AGENDA
PLANNING COMMISSION MEETING
Chesterfield City Hall
690 Chesterfield Parkway West
Monday, March 24, 2025
7:00 PM

Planning Commission Staff Report

Parkway West High School Sign Package Comment Response Letter

Planning Commission Staff Report

Figure 8: Landscape Plan

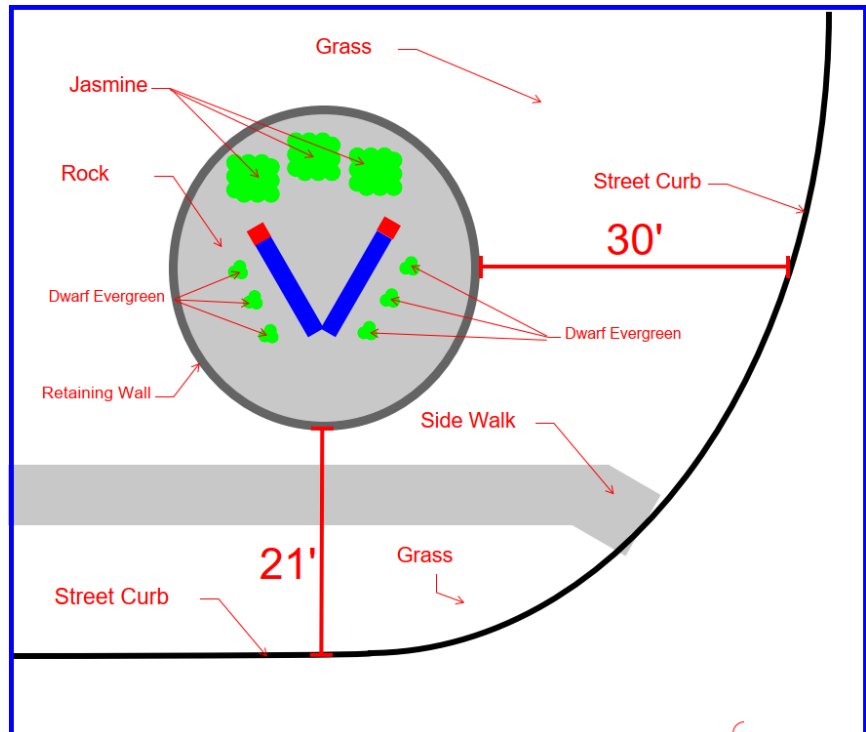
3. Please provide the landscaping for the proposed freestanding sign.

As per City of Chesterfield Unified Development Code, all permanent freestanding signs must include landscaping, which may consist of, but is not limited to, shrubs, annuals, and other materials, placed around the sign base or structural supports. The proposed monument sign will incorporate the existing landscaping. The Monument sign is positioned on top of the existing circular retaining wall, with the applicant proposing dwarf evergreens around the sign.

Figure 6: Proposed sunroom outlined in red

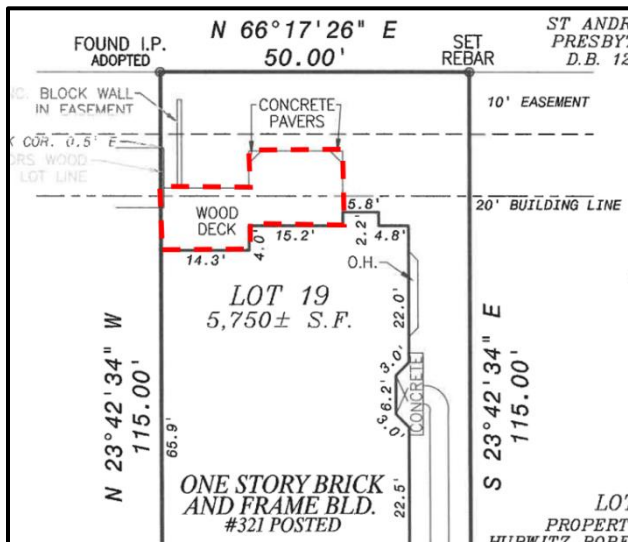
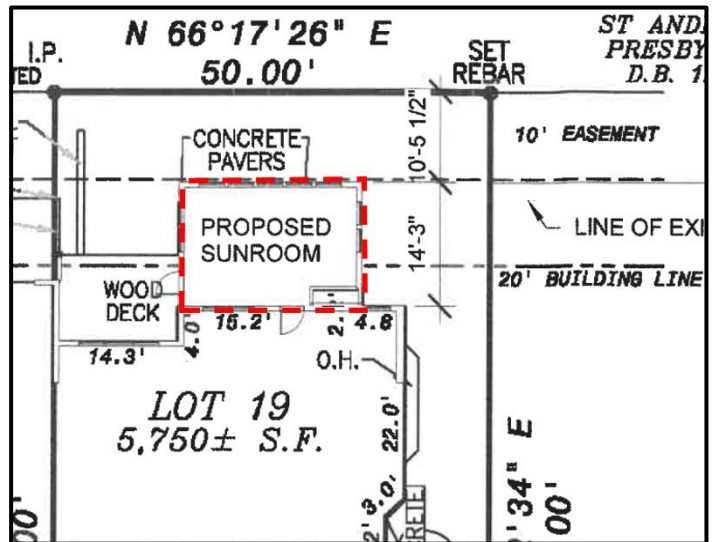
The applicant would like to replace the existing deck with a sunroom, encroaching an additional foot into the setback.

The second step is to obtain final approval from the Planning Commission through a Partially Amended Site Development Plan to allow the further encroachment into the rear setback for Lot 19. The total encroachment into the setback would be 10 feet.

SHEET NO. **A.11**

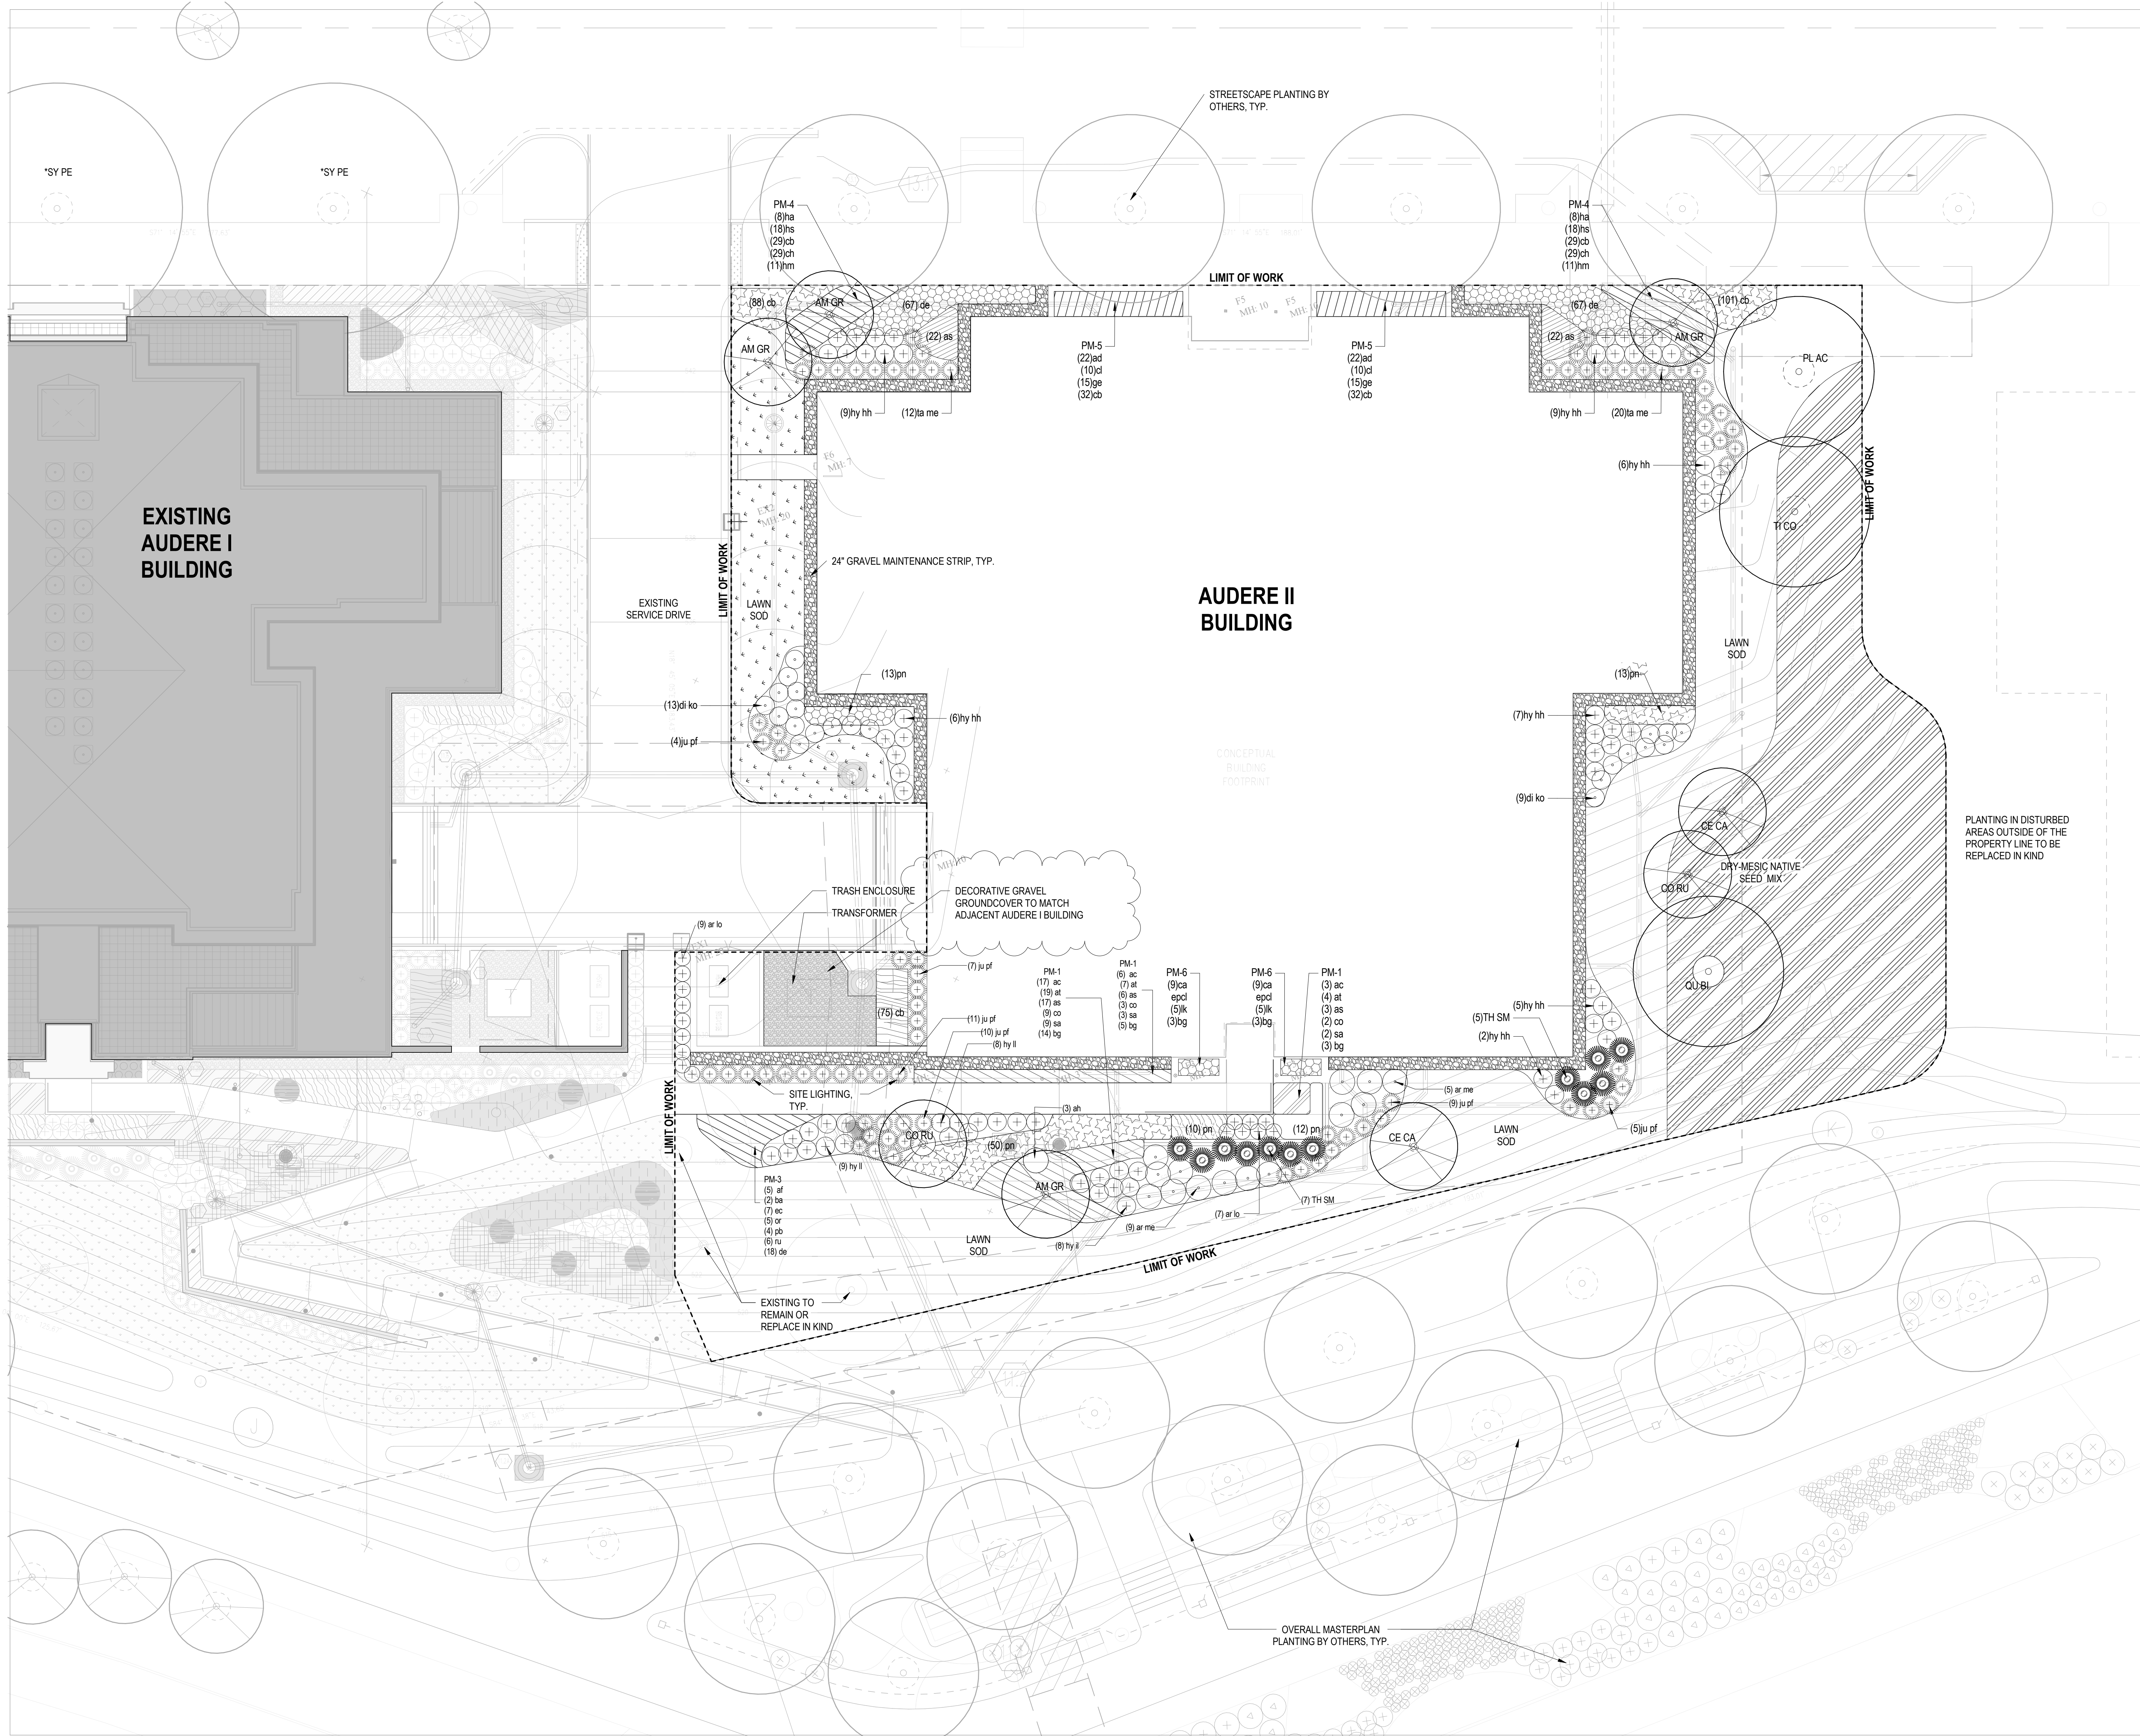
A modification is being requested in regards to the rooftop mechanical screening requirement. Ordinance 3161 states, *“rooftop mechanical equipment shall be permitted on roof within architecturally designed, fully enclosed penthouses that complement the building design”*. The applicant is proposing to screen the rooftop equipment on all visible sides with materials that are an integral part of the architecture. A full narrative of the modification request and a roof plan has been provided in the Planning Commission packet. The proposal is the same as what was approved for the condo building on Lot 2B-1.

We request a modification to Section IG.5 of Ordinance No. **3161**, which states: "rooftop mechanical equipment shall be permitted on roofs within architecturally designed, fully enclosed penthouses that complement the building design." We are proposing to enclose the elevator overrun and rooftop equipment with a cohesive material with consistent top trim that is an integral part of the architecture and will not visually weaken the design of the structure, per UDC Section 405.04.010. The top of the enclosure will remain open for free ventilation.

The project was reviewed by Architectural Review Board on March 13th, 2025. At that time, the Board made a motion to recommend approval, as presented, including the modification request by a vote of 5-0.
